# Addendum

Project: West Toronto Community Health Services  
Community Health Centre

Addendum No.: 04

## Architectural Addendum No. A04

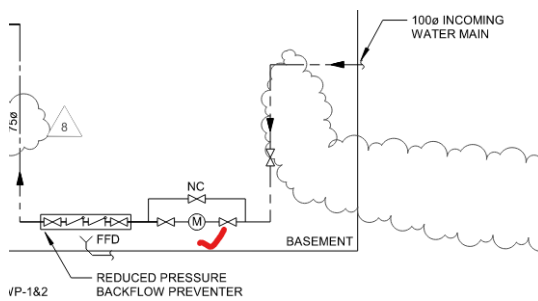
*Per mech drawing M-601, audible & visible temp alarm is required to connect to BMS (please refer snip below). Kindly confirm that this audible & visible temp alarm system shall be provided and installed by mechanical contractor and scope of BAS contractor is limited to have a dry contact alarm to BAS.*

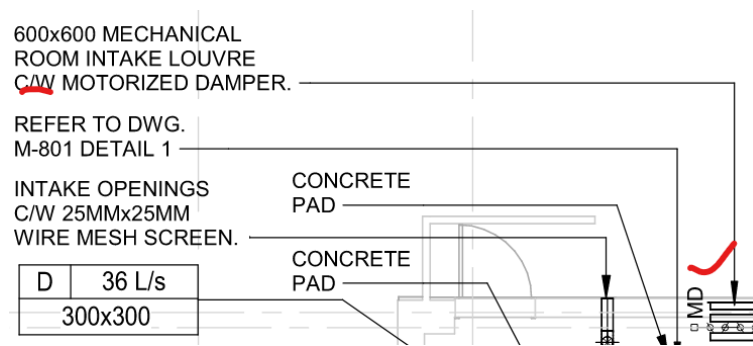
*Kindly refer snip below and confirm that louver manufacturer shall carry supply scope of damper and actuator along with louver.*

STANDARD TYPICAL  
PARTITIONS

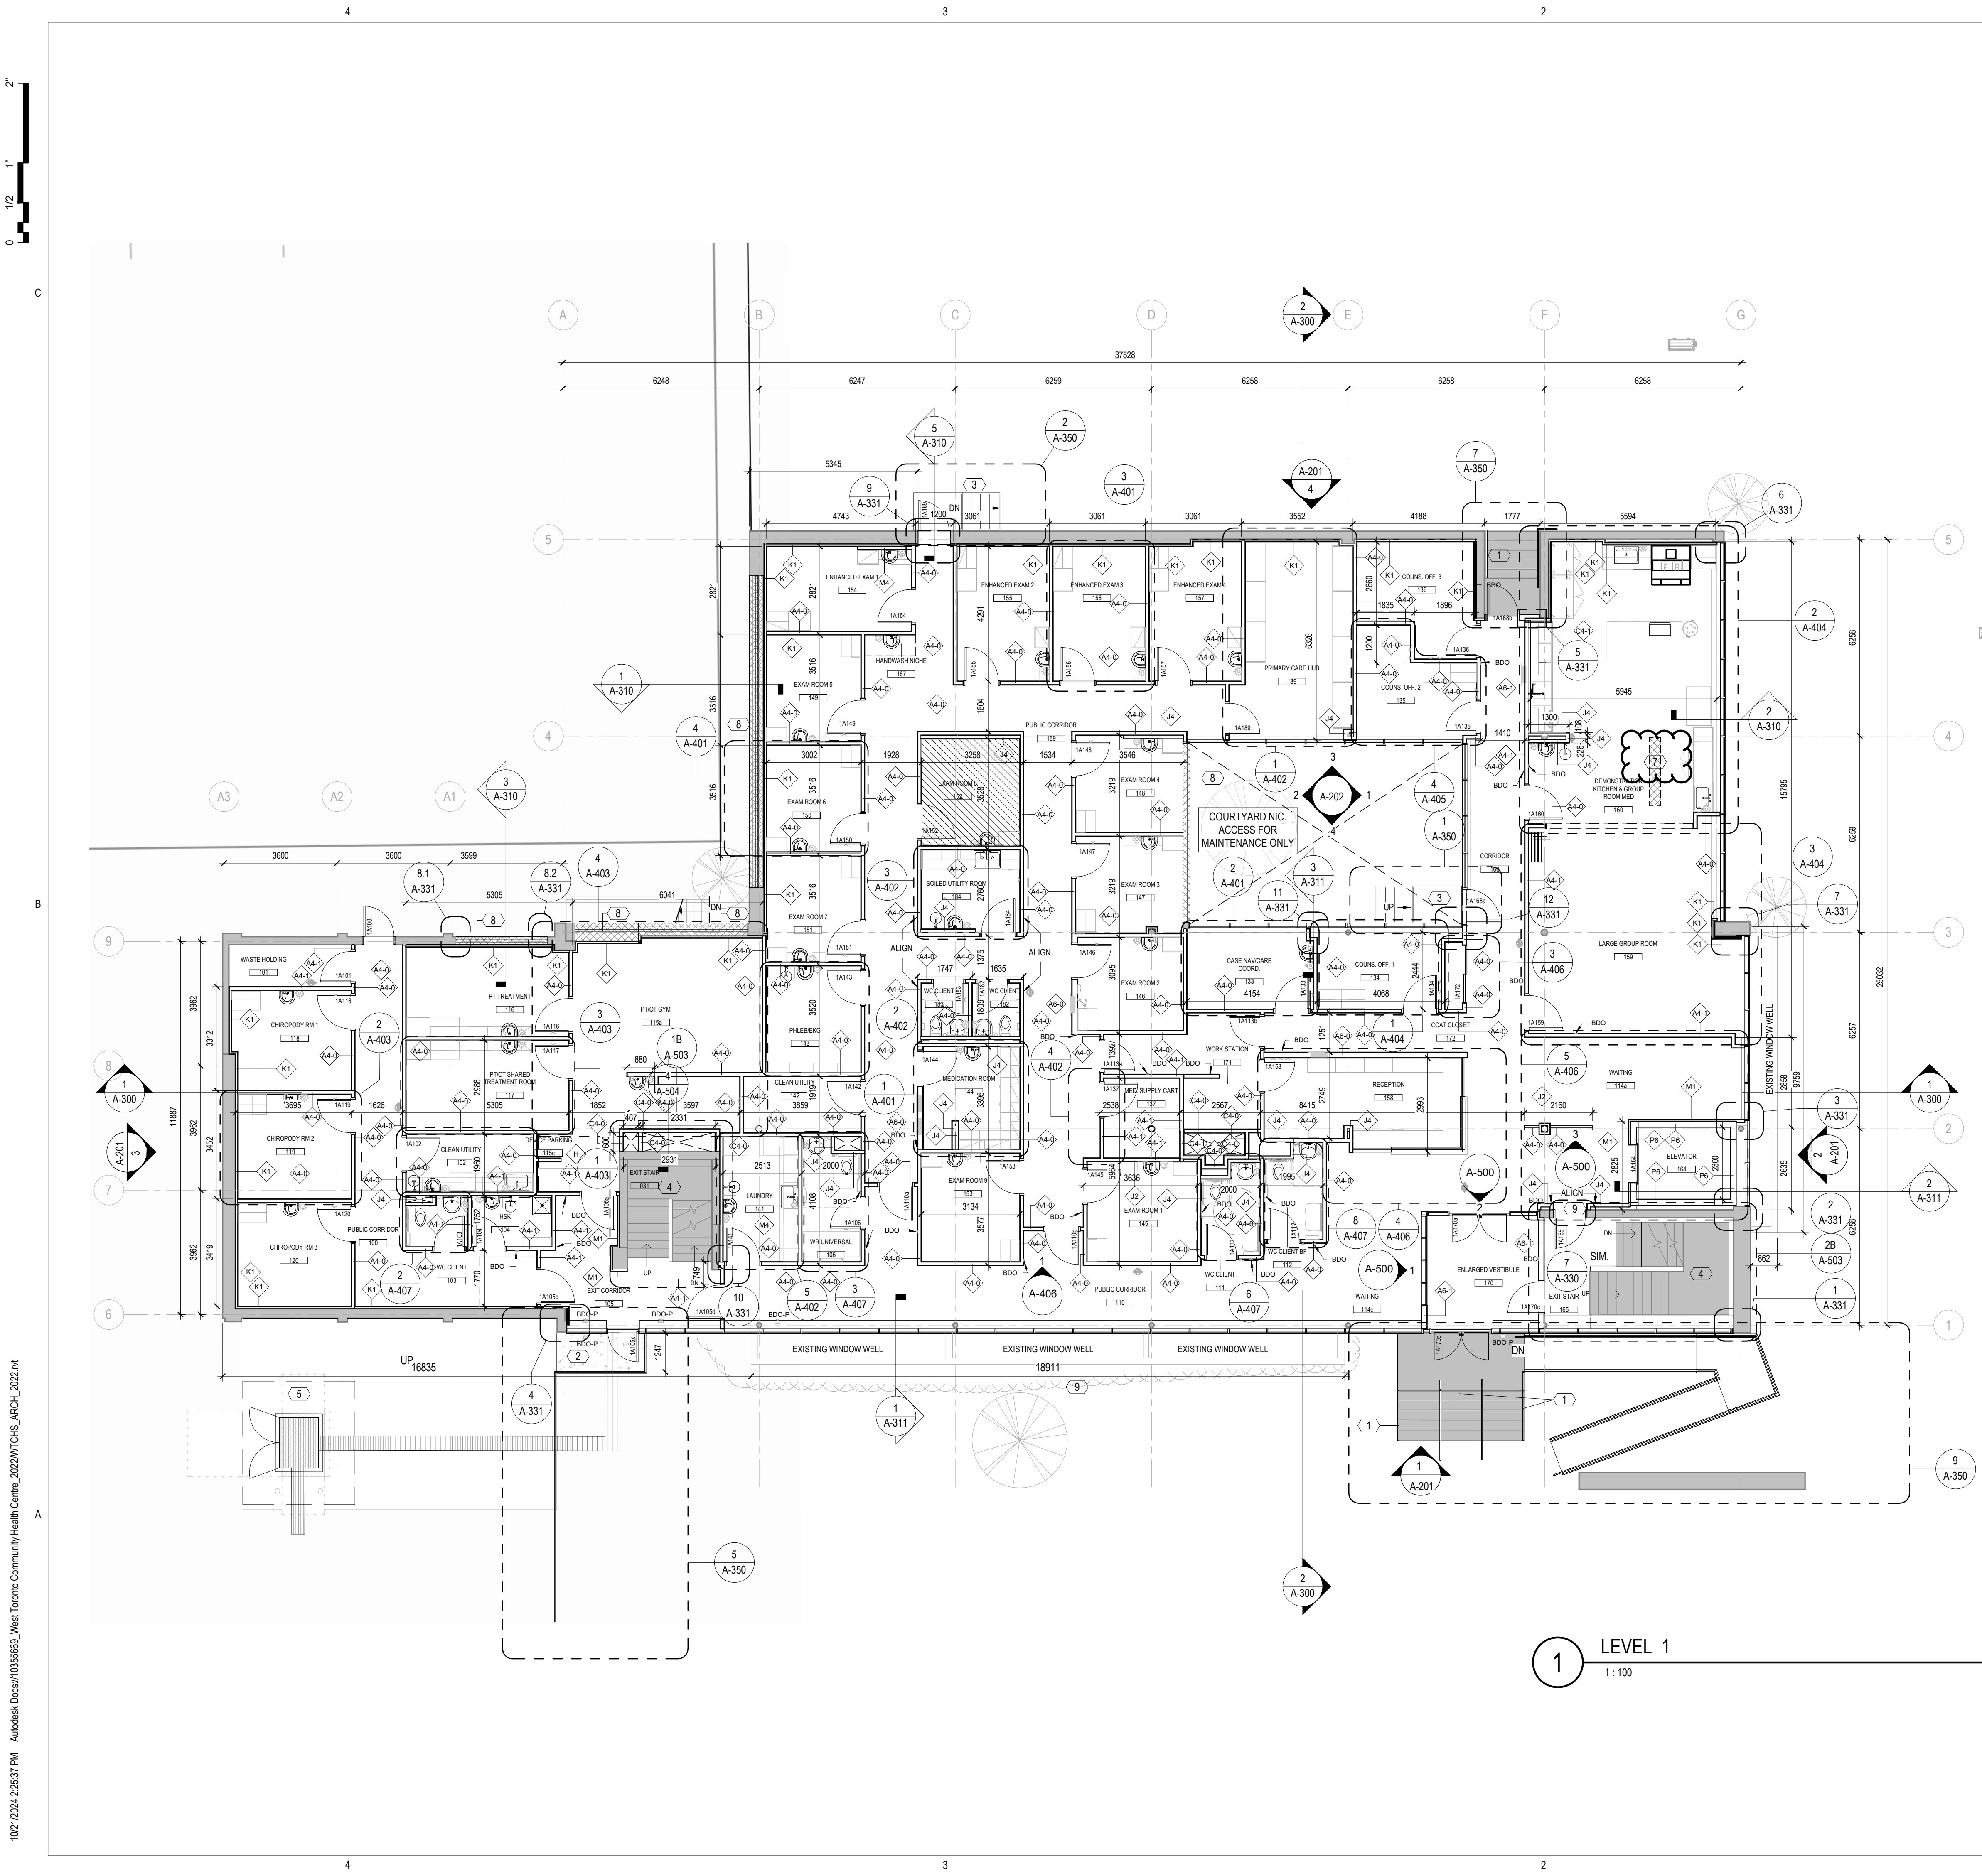
*Dwg A -010 general partition notes 14 states refer to sheet A721 and A722 for additional partition details and framing information. Drawings A721 and A722 are not issued with the tender. Please advise.*

**Refer to Drawing A-010 STANDARD TYPICAL PARTITIONS reissued herewith, dated 2024.10.23.**

## LEVEL 1 FLOOR PLAN

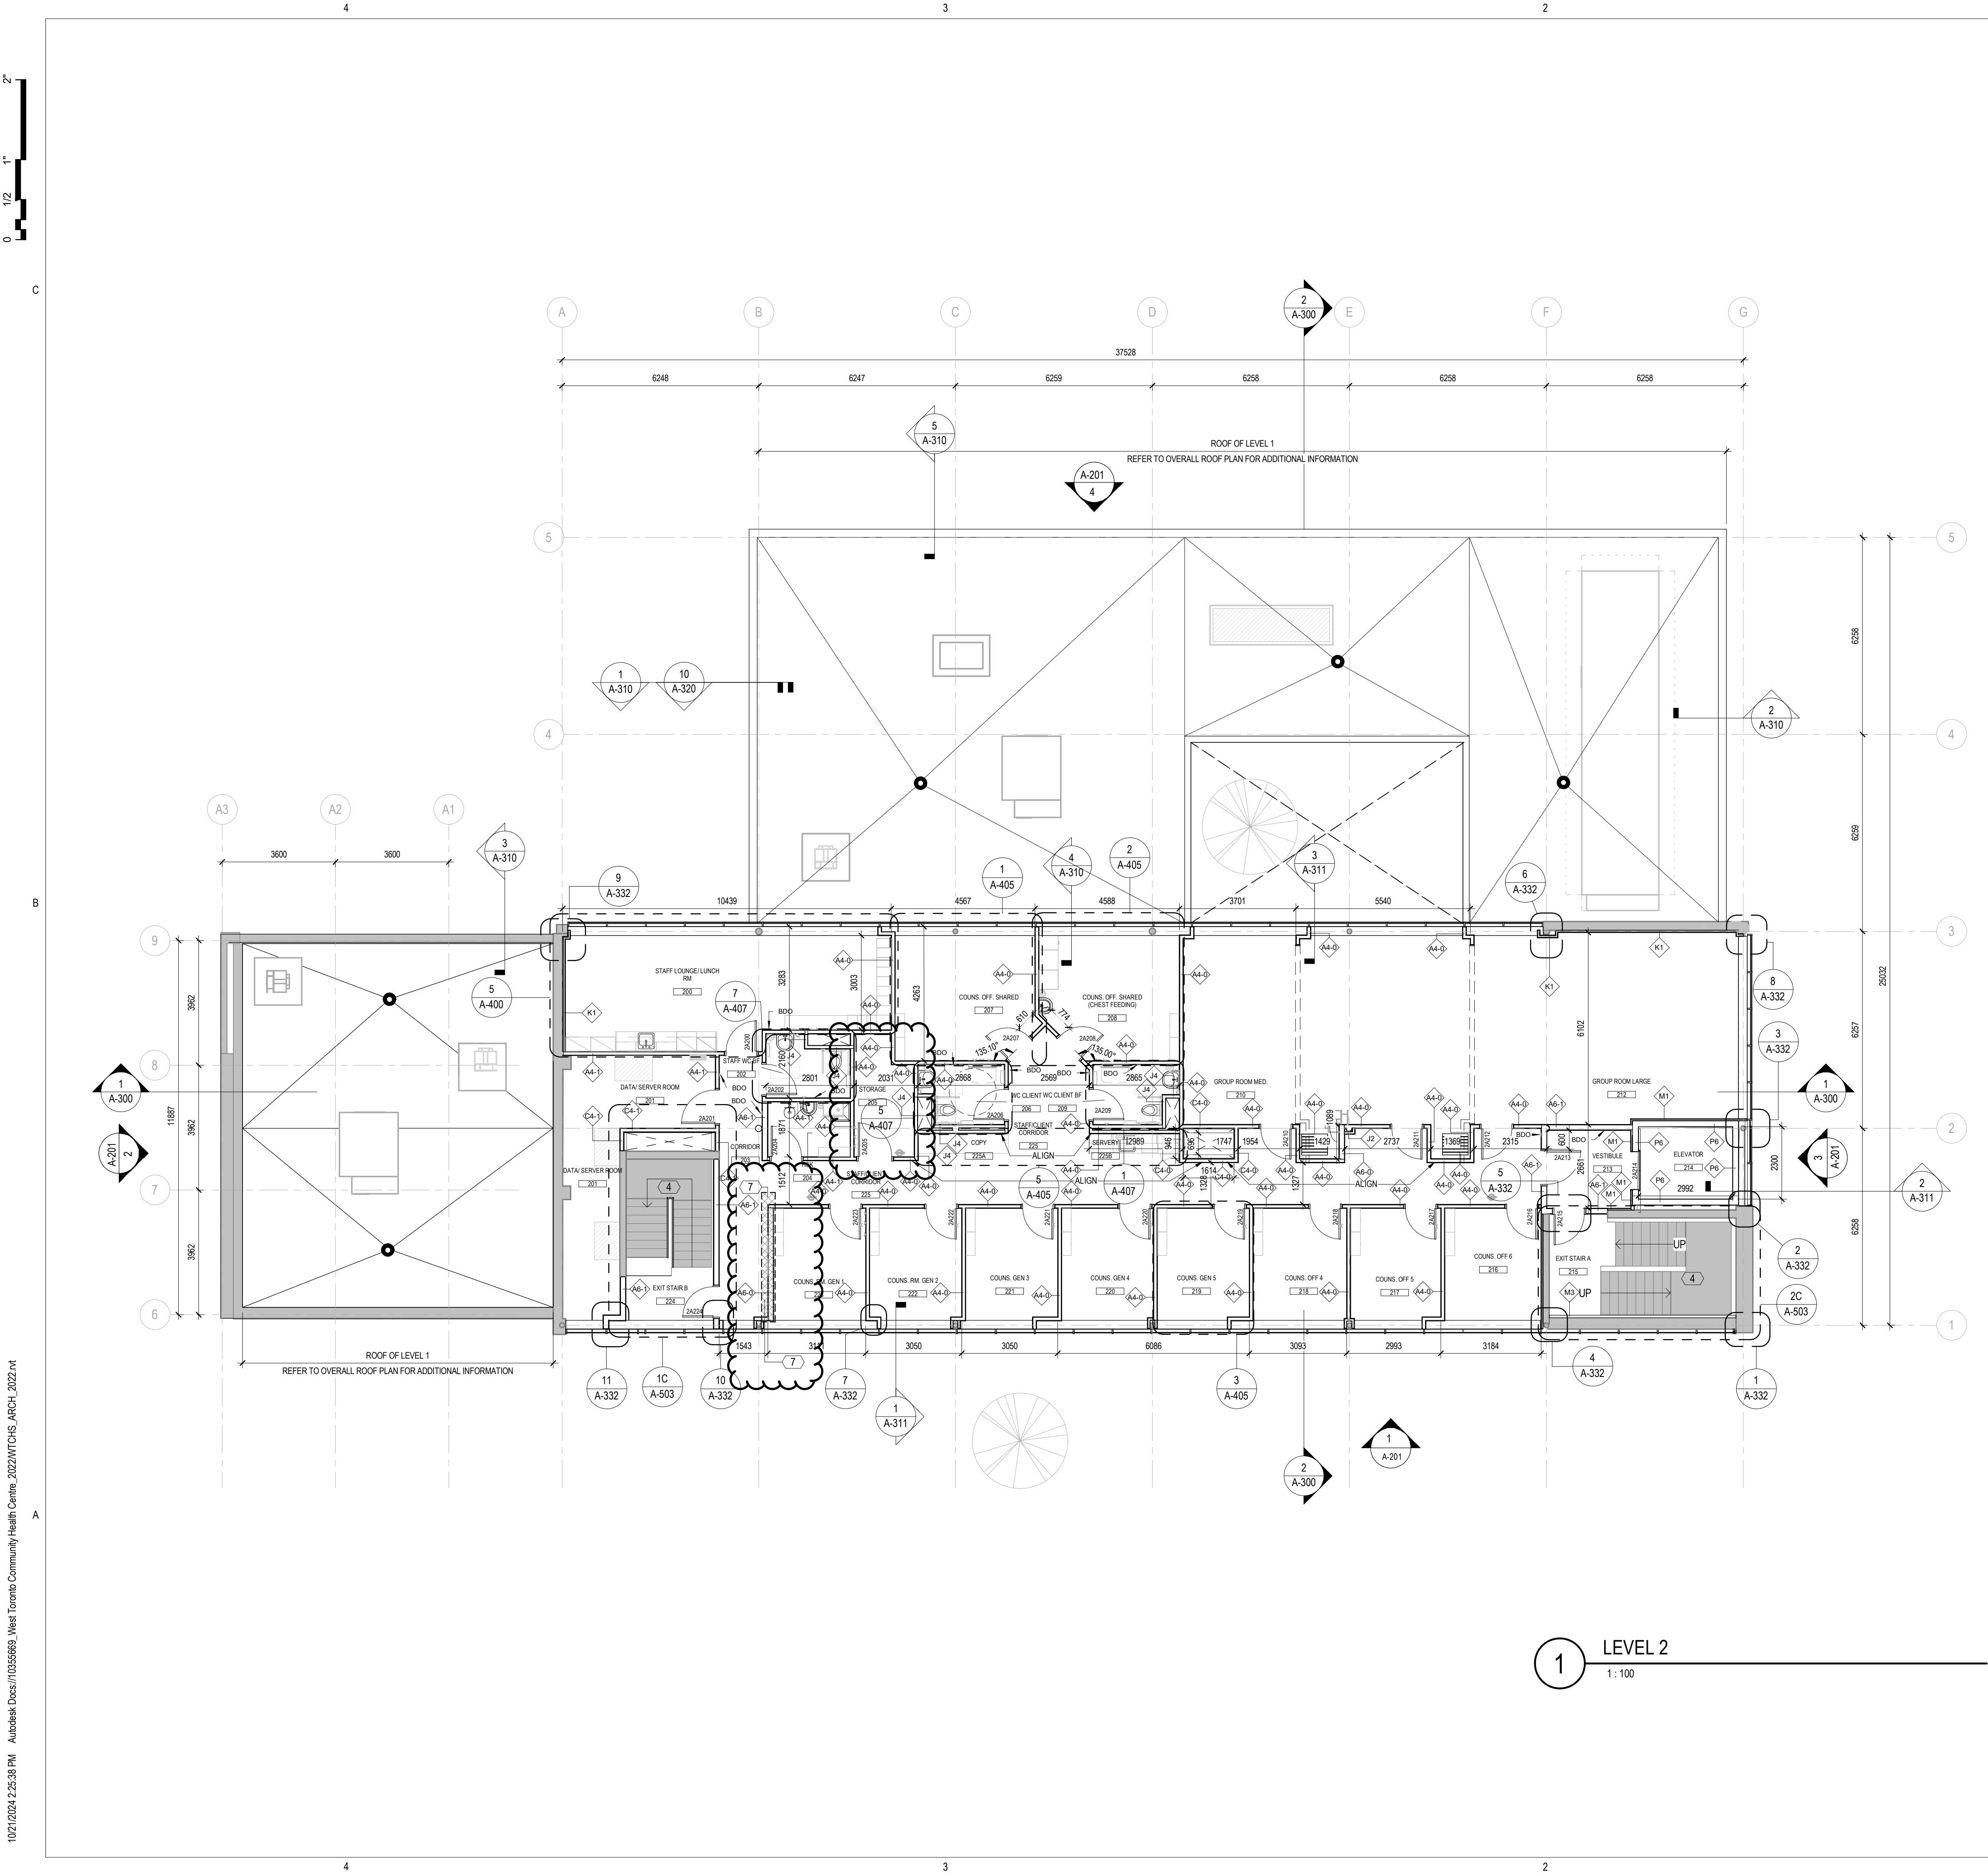
*Dwg A-101 Note 7 says new concrete slab infill. We could not be able to find note 7 in any of the floor plans. Where does this apply? Please clarify.*

Refer to Drawing A-101 LEVEL 1 FLOOR PLAN and A-102 LEVEL 2 FLOOR PLAN reissued herewith, dated 2024.10.23.

**A** **DETAIL - S.S. DISHROOM WALL PANEL**  
N.T.S.

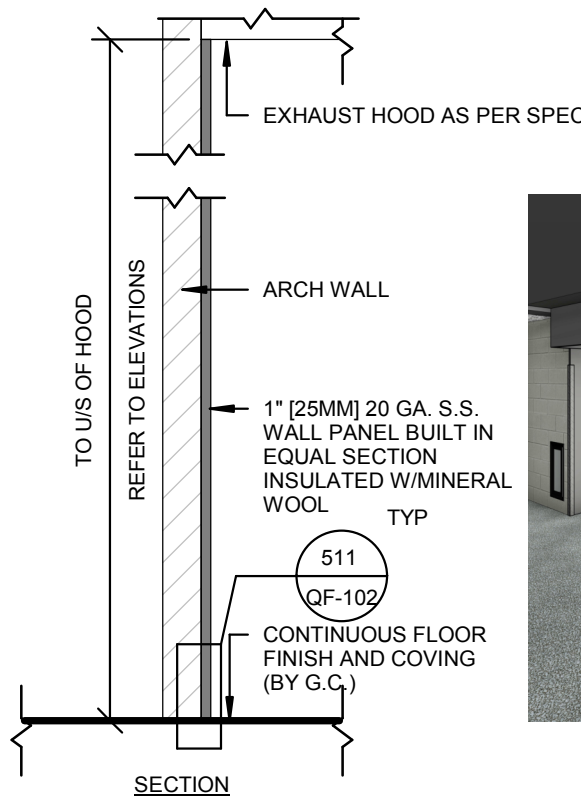
- Stainless steel "Z" strip supplied and installed full length at base of wall panel. Top section to fully extend 102mm behind bottom edge of wall panel, fastened and sealed watertight to the architectural wall. Bottom section to extend 25mm down over the floor coving and to be sealed watertight. Refer to Detail 511.

**2** **DETAIL - S.S. HOOD WALL PANEL**  
N.T.S.

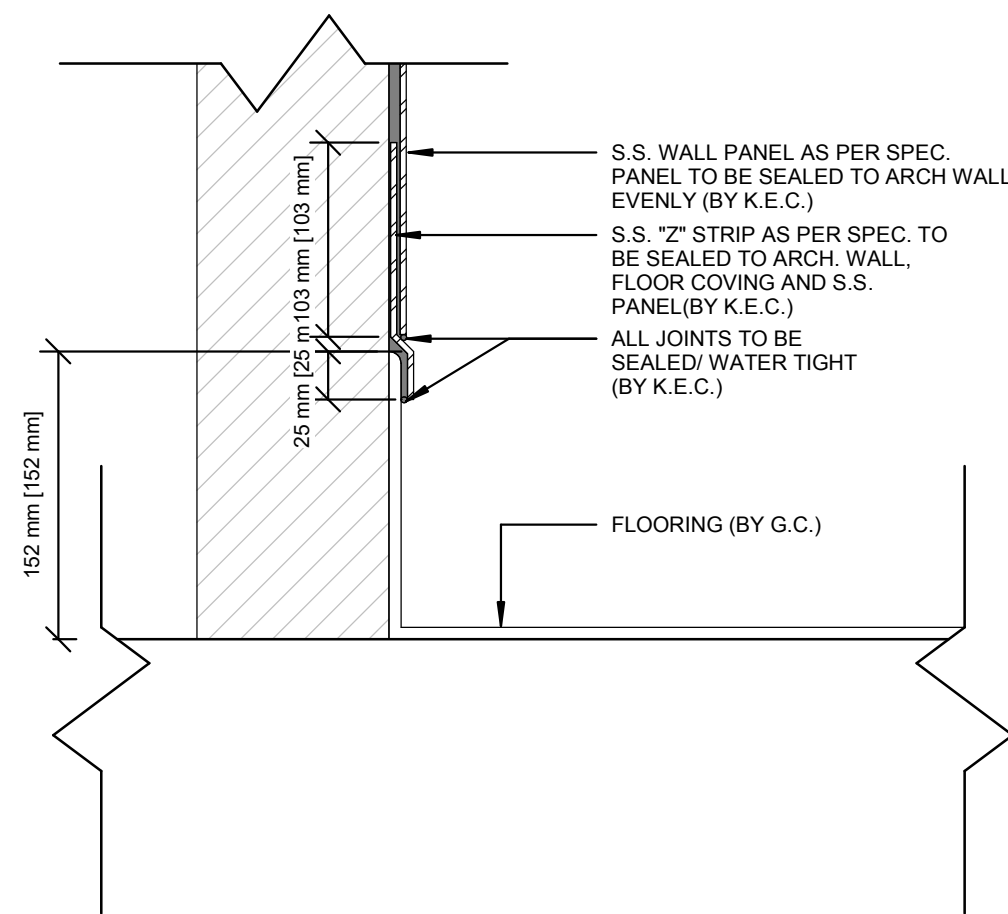
- 20 ga. 25mm thick mineral wool insulated stainless steel wall paneling to cover the architectural wall from the top of the finished floor to the underside of the exhaust hood. Panel is to be double wall construction as per Detail 2.
